# UNITED STATES PATENT AND TRADEMARK OFFICE

APPLICATION NO.	FILING DATE	FIRST NAMED INVENTOR	ATTORNEY DOCKET NO.	CONFIRMATION NO.
10/528,502	08/01/2005	Thomas Dörner	54651/DBP/M521	4395
23363 7590 06/25/2007 CHRISTIE, PARKER & HALE, LLP PO BOX 7068 PASADENA, CA 91109-7068			EXAMINER CROWE, DAVID R	
			ART UNIT 2885	PAPER NUMBER
			MAIL DATE 06/25/2007	DELIVERY MODE PAPER

<b>Office Action Summary</b>	Application No. 10/528,502	Applicant(s) DORNER, THOMAS	
	Examiner David R. Crowe	Art Unit 2885

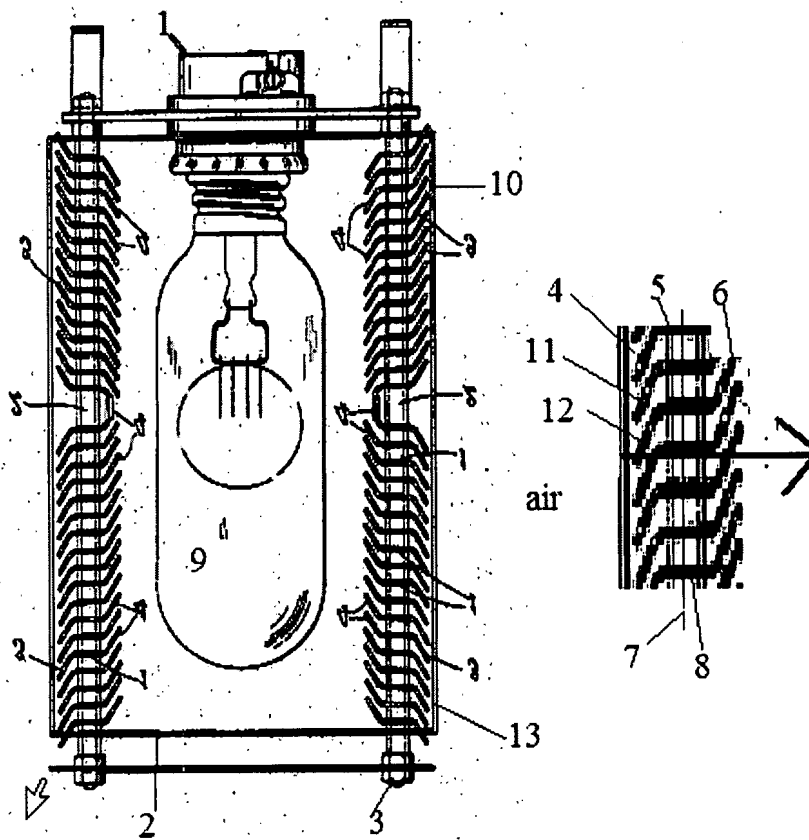
Re claims 1 and 16: McCormack discloses (see below) a spotlight for cinema with a light source [9]; a spotlight housing surrounding the light source with lower part [2] comprising at least one side wall [3], and an upper part [top half], including a transparent cover [inherent to receiving light from the source]; and a ventilation shaft [10] mounted on at least one side wall [3] wherein the shaft comprises: an air inlet aperture [plane of shaft 10], an air outlet aperture defined along a plane [7] and a plurality of ribs [12] defining a plurality of ventilation ducts [11] there between, wherein each rib comprises a first rib section [4] extending to the air inlet aperture, a second rib section [5] extending to the air outlet aperture and bent relative to first section [4]. The ribs further comprising air guide sections [8] extending from the air outlet aperture and projecting beyond the air output aperture. The bottom rib is the first rib and a second rib is defined as the rib above the first rib [to provide definition in the claim not patentable structure] where the first rib has an air guide section [8] that projects entirely perpendicular from the plane of the air outlet aperture and the second rib has an air guide section [8] that projects entirely at an angle relative to the plane of the air outlet aperture in a direction away from the plane. [The claim fails to provide sufficient limitation to the location of the inlet and outlet. Therefore under the broadest reasonable interpretation of the examiner, the inlet is defined as at the bend of rib

portions 4 and 5, therefore allowing the first portion 4 to extend to i.e. approach the inlet. The outlet aperture plane is then defined as the plane perpendicular to the second section 5 and dividing second section 5 from guide section 8 therefore allowing the second section to "extend to" or approach the outlet aperture. Guide portions 8 are then perpendicular to the outlet plane. Guide portions 8 are similarly at an angle of 90 degrees to the plane of the air outlet aperture. Lastly the guide portion 8 is interpreted as entirely perpendicular and entirely at an angle because the upturned portion 6 shown in the figure below can be viewed as its own item entirely in addition to the claimed features as allowed by the inclusive claim language.]

Re claim 3: McCormack discloses each second rib section [5] being horizontal.

Re Claim 5: McCormack discloses the inlet to the ventilation shaft at the leading edge of the first rib section [4] flush with housing body [13]. [The inlet aperture can be interpreted as the leading edge without disrupting the interpretation of claim 1 since "extending to" is shown not to mean "ending at", but can also be "being from" as long as a side of the first rib section is adjacent to the inlet aperture.]

Re claim 8: McCormack shows the ribs at constant intervals.

Re claim 9: McCormack discloses ventilation on both the left and right side of the housing as shown in the figure.

Re claims 13 and 17: As discussed in claim 1 above, the second sections [5] extend perpendicularly relative to the plane of the air outlet aperture.

Re claim 2: Although McCormack fails to teach the angle of the guide portions changing relative to the distance from the base, where the guide portions are defined as section [8] alone in the figure above, it would have been obvious to one having ordinary skill in the art of cooling ventilation to adjust the guide portions to direct the cool air onto the light source as necessitated by the lamp structure. It would have been obvious that varying the angles could distribute the cooling area over a larger area of heated surface and therefore improve cooling efficiency.

Re claims 14 and 18: Although McCormack fails to teach the second rib portions [5] extending away from the base because they are parallel with the base in the figures provided, it would have been obvious to one having ordinary skill in the art at the time the invention was made to configure the ribs to maximize air flow while maintaining blockage of light. The claimed configuration lacks criticality required to make the feature patentable over the prior art as the applicant has given a variety of shaft and duct configurations with appear in the specification to be designed specifically based on their location relative to the light source and therefore the housing. However the claims
